Access Compliance Report

Public Rights-of-Way

(Curb Ramps)

Intersection ID: N/A	Main Street: IKEA_BV	Cross Street: N/A	Location: S
ADA ID: 792E8D6FF98E	Ramp Type: PerpDiag	Initial Pass/Fail: Pass	Overall Compliance: No
Codes/Mitigation Info/Possible Solution		Field Measurements/Component Compliance

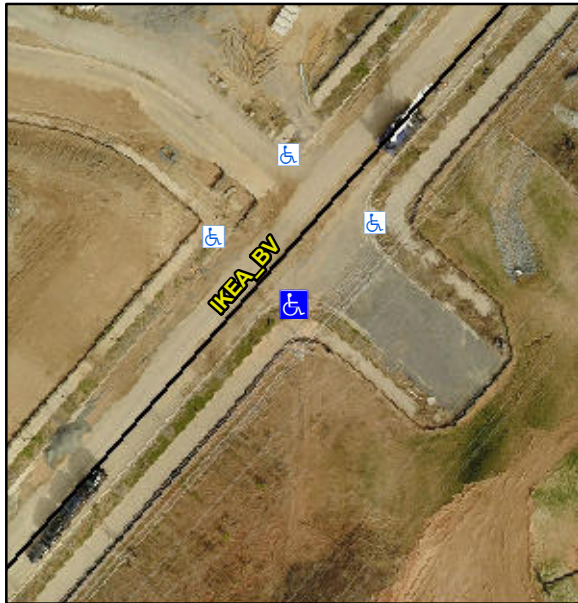
R304.5.3, R304.2.2-Perp, R304.3.2-Para, R302.7.2

Compliance	Description	Data	Compliance	Description	Data
N/A	Ramp Length (in)	95.0	Yes	Ramp Slope (%)	6.8
Yes	Ramp Width (in)	59.0	No	Ramp XSlope (%)	3.6
N/A	Flare Type LT	Sloped	N/A	Flare Type RT	N/A
N/A	Flare Slope LT (%)	5.7	N/A	Flare Slope RT (%)	8.7
N/A	Flare Traversable LT?	No	N/A	Flare Traversable RT?	No
Yes	Landing Length (in)	60.0	Yes	DWS Provided?	Yes
Yes	Landing Width (in)	60.0	Yes	DWS Contrast?	Yes
No	Landing Slope (%)	2.4	Yes	DWS Length (in)	24.0
Yes	Landing X Slope (%)	0.3	Yes	DWS Full Width?	Yes
N/A	Landing Curb? (Y/N)	No	Yes	DWS Offset (in)	2.0
N/A	Shared Landing?	No			
Yes	Gutter Ponding?	No	Yes	Gutter Slope (%)	3.0
No	Gutter Lip Ht (in)	2.6	Yes	Gutter X Slope (%)	0.1
N/A	Painted X Walk1?	No	N/A	Painted X Walk2?	No
	X Walk 1 Direction	To NE		X Walk 2 Direction	To W
N/A	X Walk 1 Width (in)	N/A	N/A	X Walk 2 Width (in)	N/A
	X Walk 1 Slope (%)	1.5		X Walk 2 Slope (%)	1.8
	X Walk 1 X Slope (%)	2.6		X Walk 2 X Slope (%)	1.8

Remove & Replace Curb Ramp With Two New Directional Ramps or Equivalent. Grind Gutter Lip.
